IE Bulletin No. 78-05

MALFUNCTIONING OF CIRCUIT BREAKER AUXILIARY CONTACT MECHANISM -  
GENERAL ELECTRIC MODEL CR105X

### 105X AUXILIARY CONTACT (CHANGEOUT OF PLUNGER ARM AND INSULATION)

FIGURE 1  
REMOVING OVERLOAD RELAY MOUNTING BRACKET

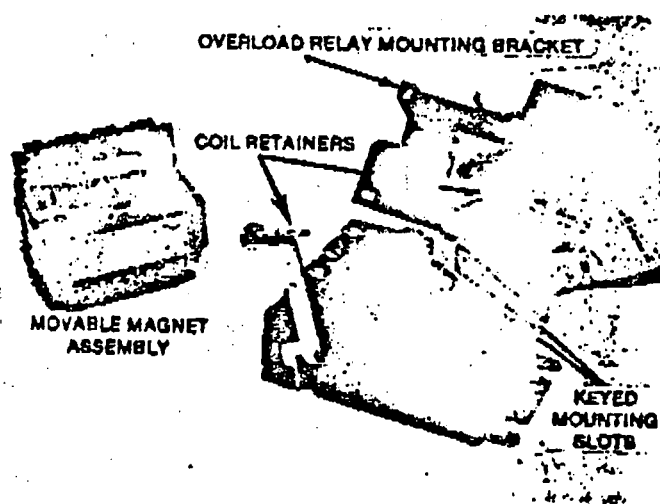
#### REMOVING OVERLOAD RELAY BRACKET (SEE FIG. 1)

1. Remove all electrical power from device.
2. Disassemble device by pressing on the coil while pulling out on the coil retainers. Move retainers back and away from coil.
3. Grasp movable portion of magnet and pull out, removing magnet assembly, coil, molded cover and movable arm in one motion. (NOTE: On reversers or multispeed starters, this magnet assembly is linked to the mechanical interlock arm between contactors and should be tipped toward interlock arm to facilitate easy removal.)
4. Remove overload relay bracket by sliding it out of the keyed slots in the molded base. (NOTE: If any wires are too short to allow easy removal, temporarily disconnect these.)
5. Remove overload relay from bracket by loosening screw on bottom of overload bracket.

FIGURE 2

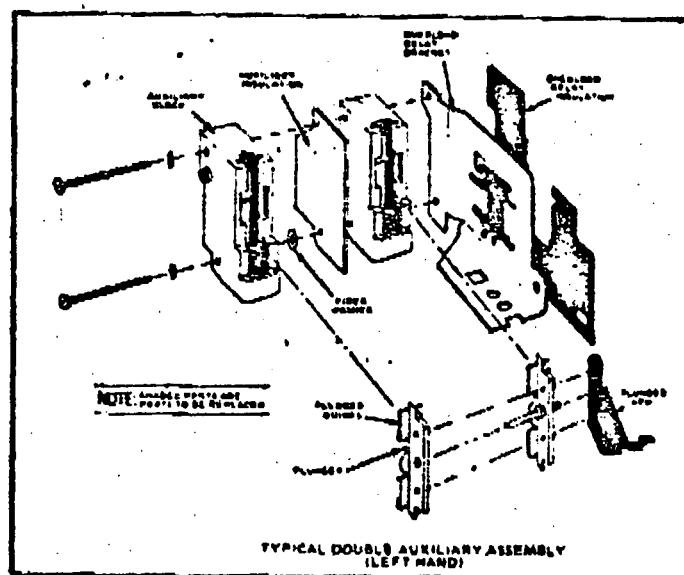
#### CHANGING PLUNGER ARM & INSULATION (SEE FIG. 2)

1. Slide plunger assembly out of auxiliary contact block, by lifting up and out.
2. Select the new plunger arm that is bent the same way as the one installed.

3. Loosen screw on plunger to release metal arm but DO NOT REMOVE SCREW FROM PHENOLIC PLUNGER (OR PLUNGERS).
4. Mount new plunger arm on plunger. Fasten arm to plunger with screw (or plunger post if installing double aux. blocks).

5. Apply thin coat of aeroshell grease along plunger guides.
6. Reinstall plunger assembly in contact block.
7. Reassemble overload to mounting bracket. Remove overload insulation and install new. (NOTE: Overload insulation must be removed and replaced with new insulation supplied with kit.)

8. Remount complete assembly on contactor base.
9. Reconnect any wires previously removed.
10. Reassemble magnet assembly to contact base (on reversers or multispeeds be sure to interlock this assembly with mechanical interlock arm. Check for free movement of armature assemblies and mechanical interlocks).

11. Observe that auxiliary contact plunger assemblies are operating properly.
